DRB CASE ACTION LOG - BLUE SHEET

Project #: 100871dp Application #: 11DRB-70212
Project Name: Del Norte Plaza
Agent: Modulus Architects Inc. Phone #:

**CITY OF ALBUQUERQUE
PLANNING DEPARTMENT
December 7, 2011
DRB Comments**

CITY OF ALBUQUERQUE
PLANNING DEPARTMENT
DEVELOPMENT REVIEW BOARD

12 TYP. END ISLAND W/ WALK
Scale: N.T.S.

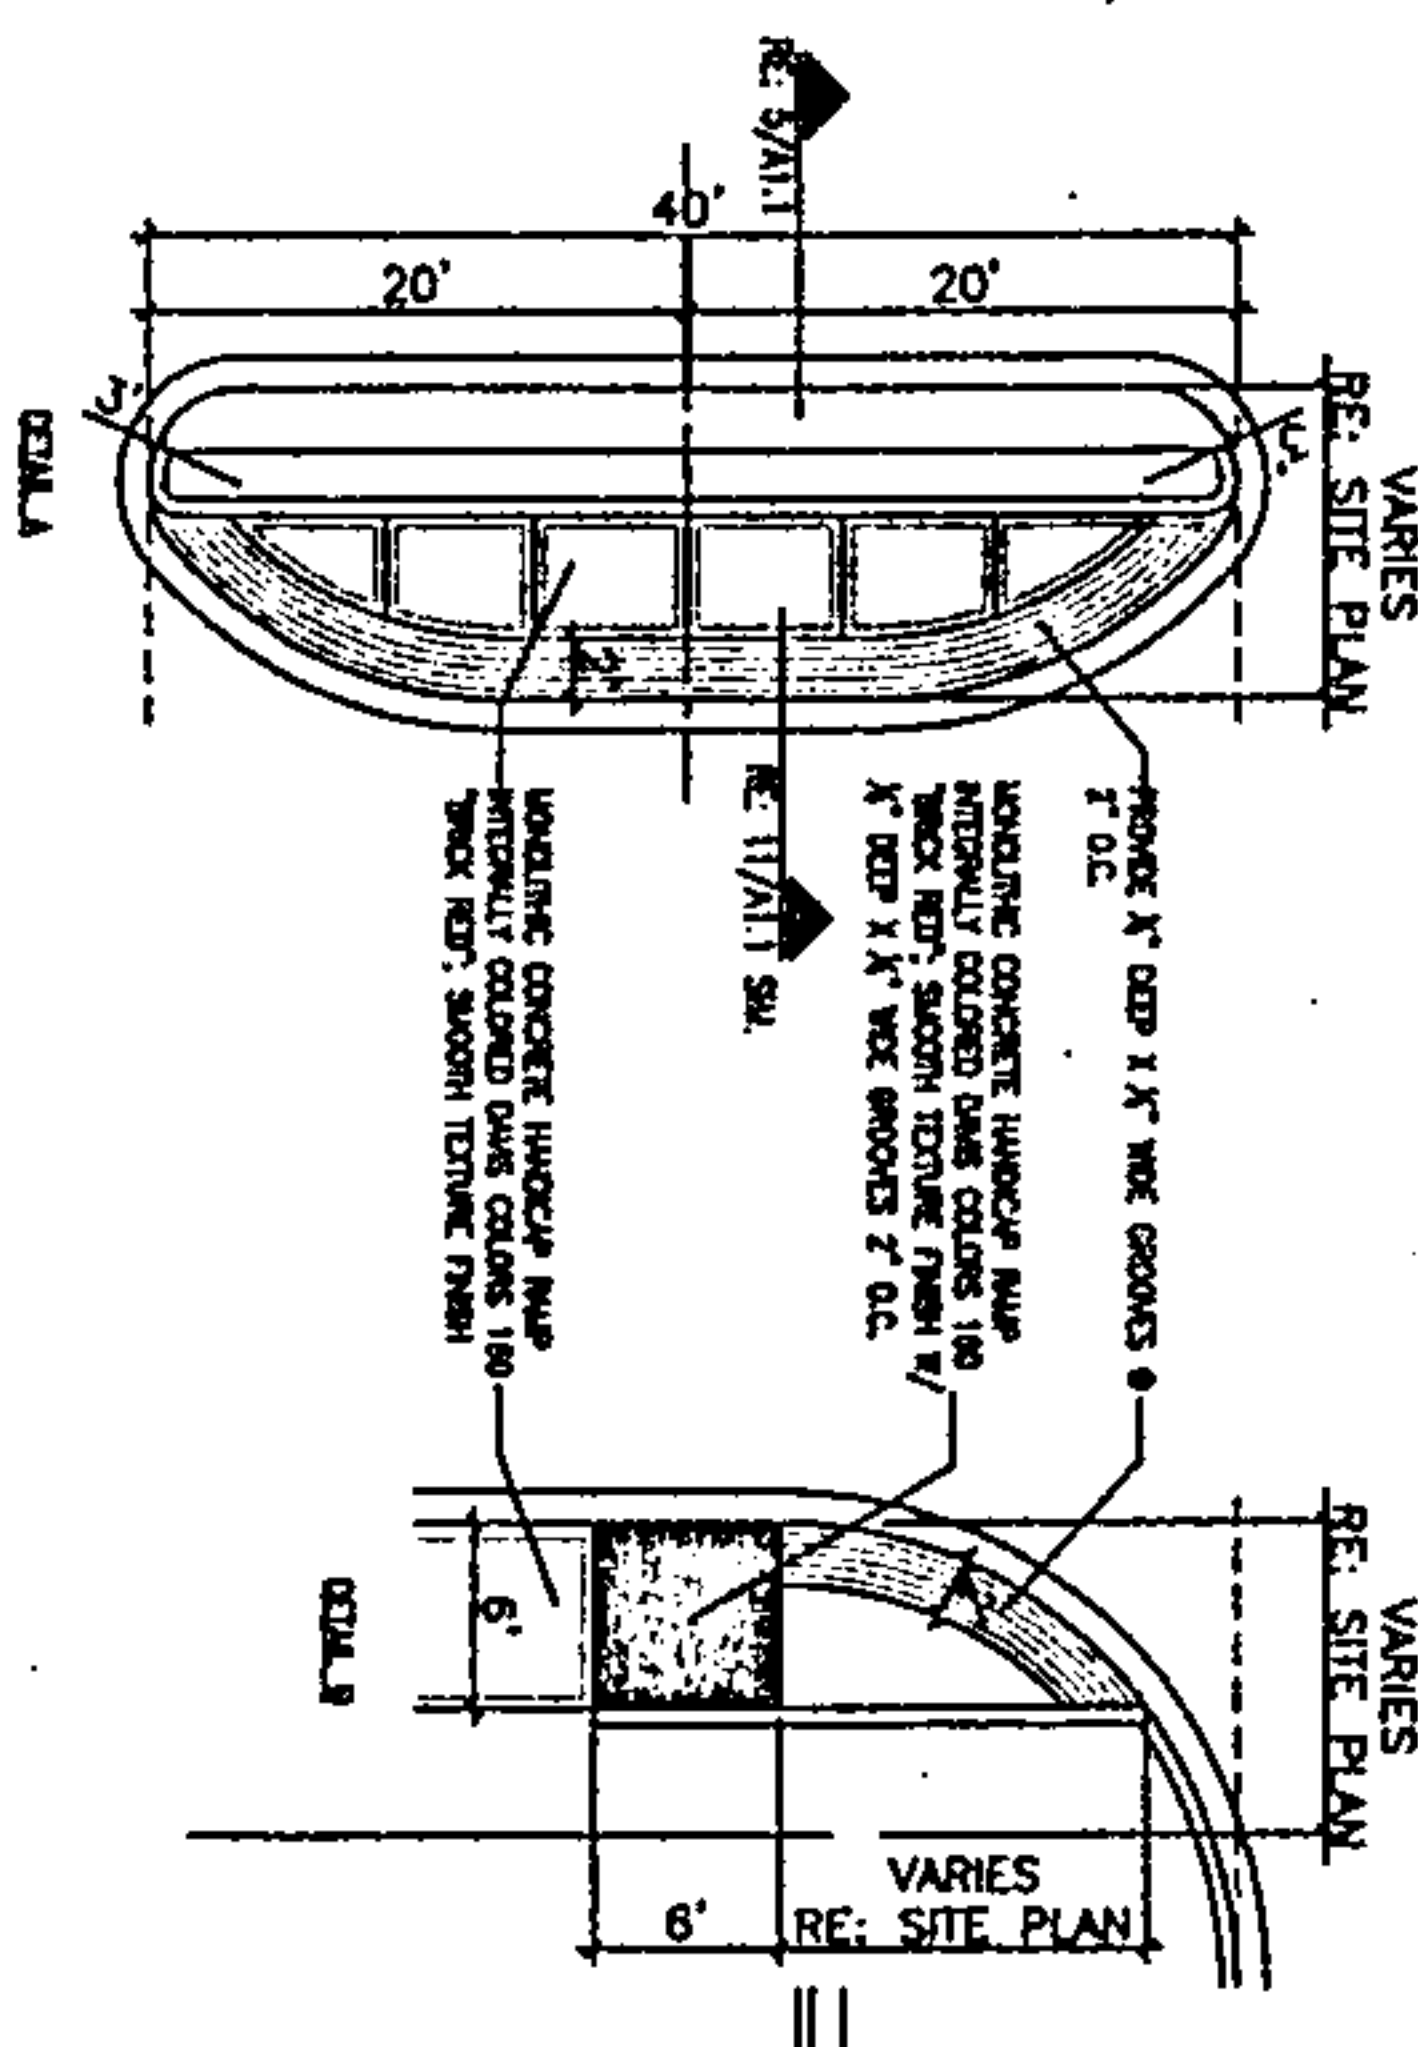
- Detail 16 (Sheet A1.1) does not define the maximum slope of the ramp.
- Detail 12 (Sheet A1.1) does not define the maximum slope of the ramp.
